PREPARED FOR THE PLAN COMMISSION

Project Address: 437-445 W Johnson Street, 430-440 W Dayton Street, and 215-221 N Bassett Street (District 3 – Alder Verveer)

Application Type: Zoning Map Amendment, Demolition Permit, Conditional Use, and Certified Survey Map Referral

Prepared By: Chris Wells, Planning Division
Report includes comments from other City agencies, as noted.

Image 1: Ground floor layout of the building's 6-story mass. Left: Original proposal with an exterior walkway leading to individual townhouse entrances; and Right: Revised proposal with the walkway removed and replaced with private patios

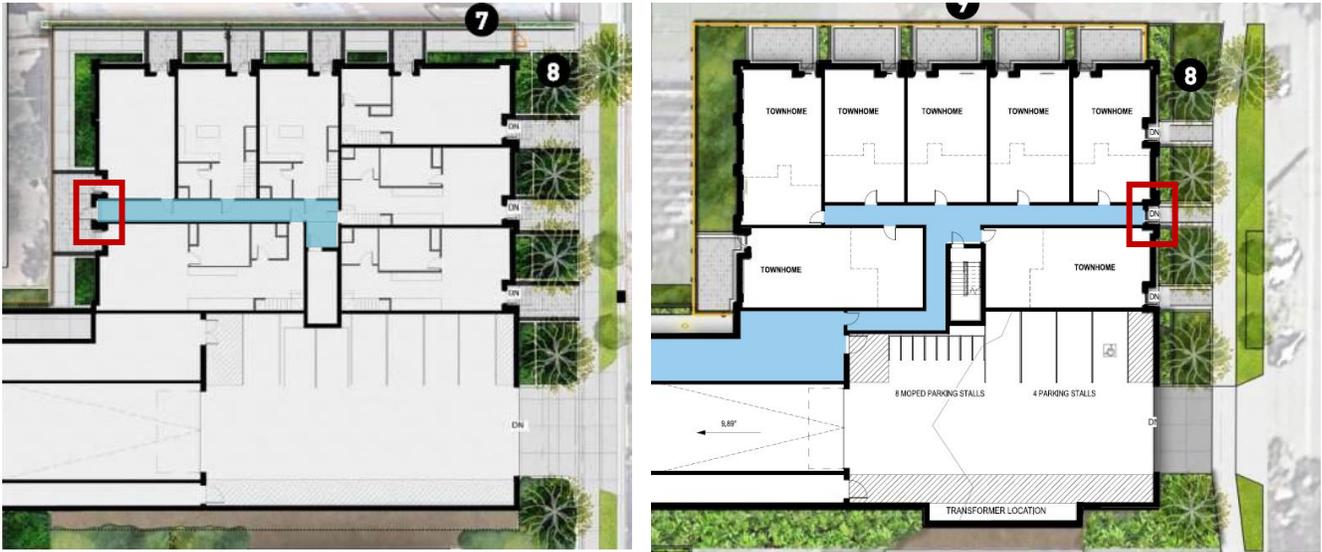
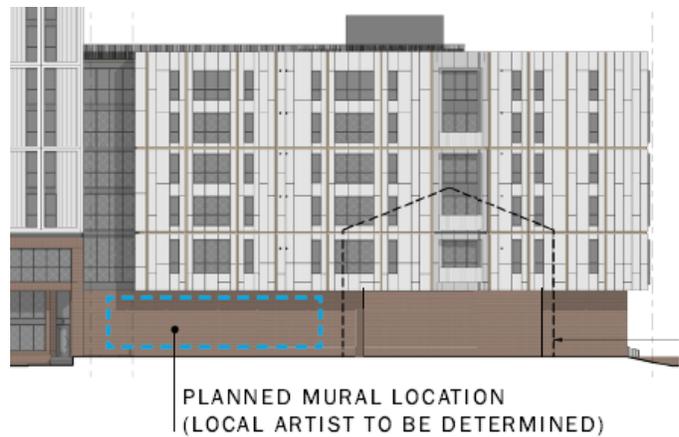
Regarding the changes related to the various residential entries of the building’s 6-story mass, most notably, the applicant has flipped the common entrance from the west to the east (W Dayton Street) side of the building and removed the exterior entries for all of the townhouse units, save for the two units which face W Dayton Street. Private patios now occupy the space which was previously occupied by the internal sidewalk and front stoops. (See Image 1 below with the common entry indicated in red in the original proposal (on the left) and the revised proposal (on the right).) This same change was also made to the townhouse entries located along the east façade of the 12-story mass.

Regarding the design of the relocated common entrance to the W Dayton Street façade and the fact that it appears quite similar to those of the adjacent townhouse entries, the UDC's motion of approval at their May 31, 2023 meeting included a condition of approval that "Additional landscaping or visual cues shall be provided to distinguish the individual entries from the common entryway on W Dayton Street."
